TECHNICAL BULLETIN NO. 20

June 2006

20.2 UPDATES TO AUTOCAD STANDARDS AND UDACS

THRUST BLOCK INSTALLATION

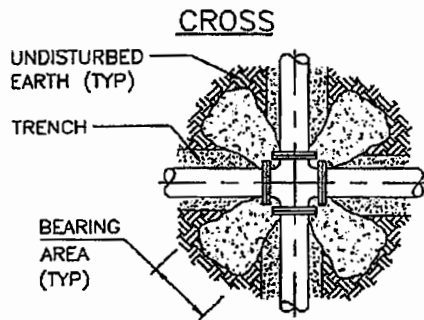
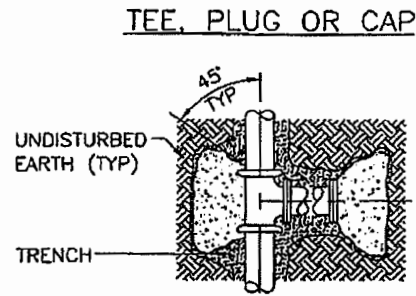
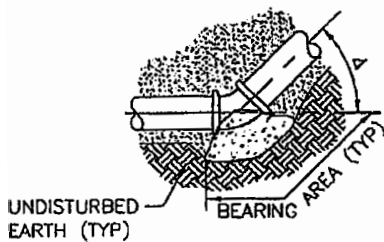
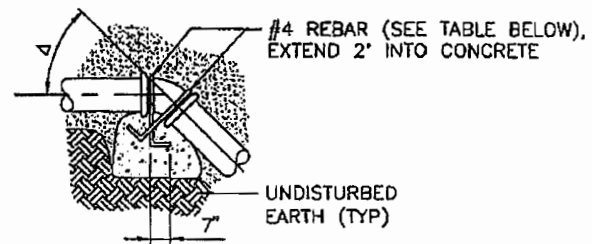
Modifications have been made to AutoCAD Standard PL11-1, *Thrust Block Installation*, (UDACS Plate No. 5) and AutoCAD Standard PL11-2, *Anchor Block Details for Reducers and Gate Valves*, (UDACS Plate No.3) to better illustrate actual field conditions of most installations. Please see attached updates.
